# Service Bulletin

Bulletin No.: 23-NA-002

**Subject: Charge Air Cooler (CAC) Icing, Check Engine Lamp Illuminated, Possible P0299, P2227 and/or P0300 DTCs Set**

6230265

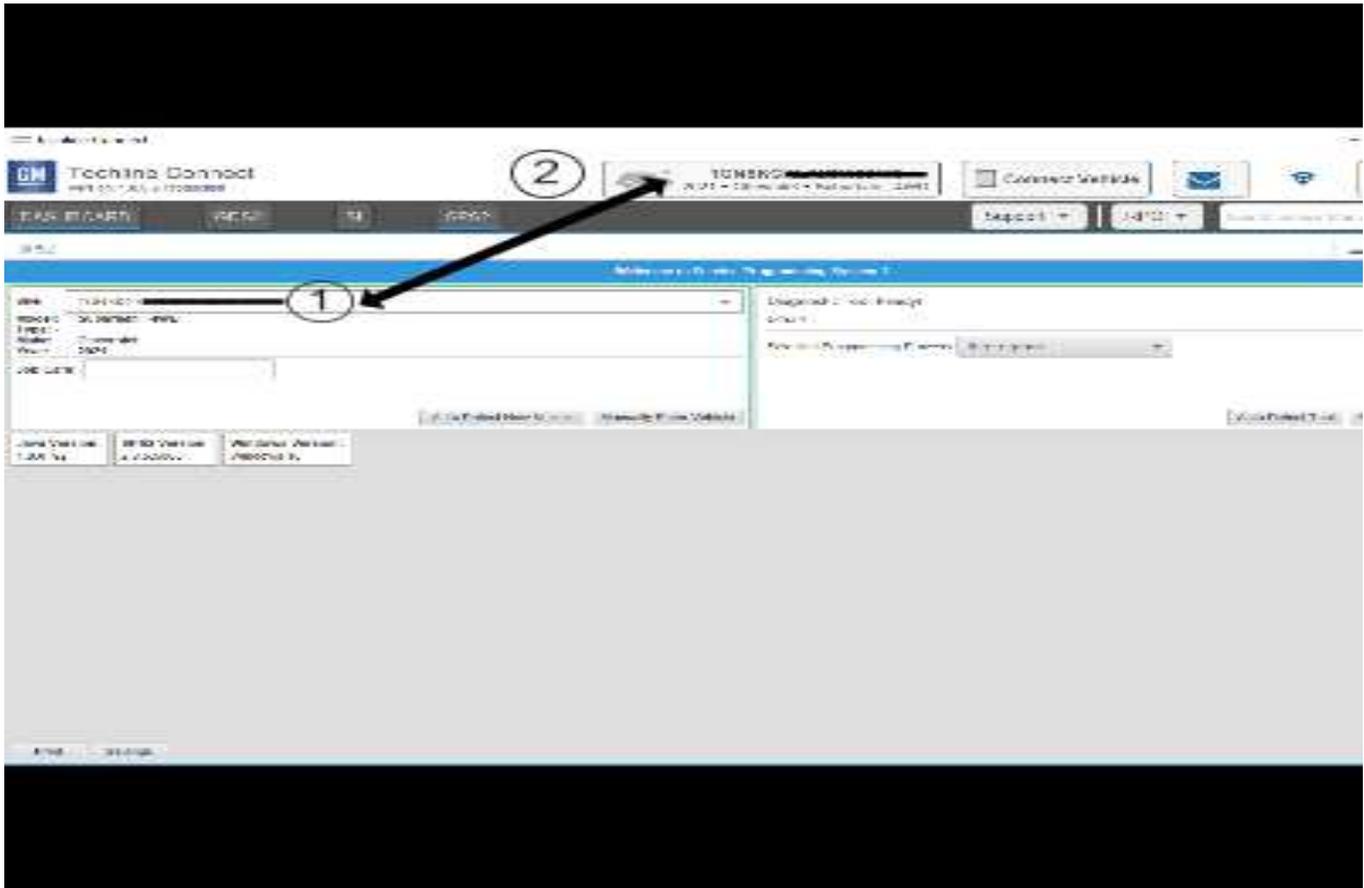
<b>Involved Region or Country</b>	United States, Canada, Mexico, Europe, Uzbekistan, Russia
<b>Additional Options (RPOs)</b>	
<b>Condition</b>	Some customers may comment on a Check Engine Lamp illuminated in the DIC and/or reduced engine power. Technician may find DTCs P0299 and/or P2227, or P0300 set current or in recent history.
<b>Cause</b>	The cause of the condition may be that Ambient and PCV moisture can freeze, where ice or sludge can accumulate in the CAC, restricting flow, and causing a Check Engine Lamp, reduced engine power, and DTCs P0299 and/or P2227, or P0300 to set.
<b>Correction</b>	Update ECM calibration and add a baffle to help reduce CAC icing.

5. Remove the four push pins (1) securing the top of the Front Bumper Lower Air Baffle.

6. Install the Radiator Air Front Lower Baffle, slipping the tabs behind the outermost tabs of the Front Bumper Lower Air Baffle as circled above. Then, snap the top of the Radiator Air Front Lower Baffle in place on top of the charge air cooler.
7. Reinstall the four push pins (1) removed in step 5.
8. Reinstall the Front Bumper Impact Bar. Refer to *Front Bumper Impact Bar Replacement* in the Service Manual.
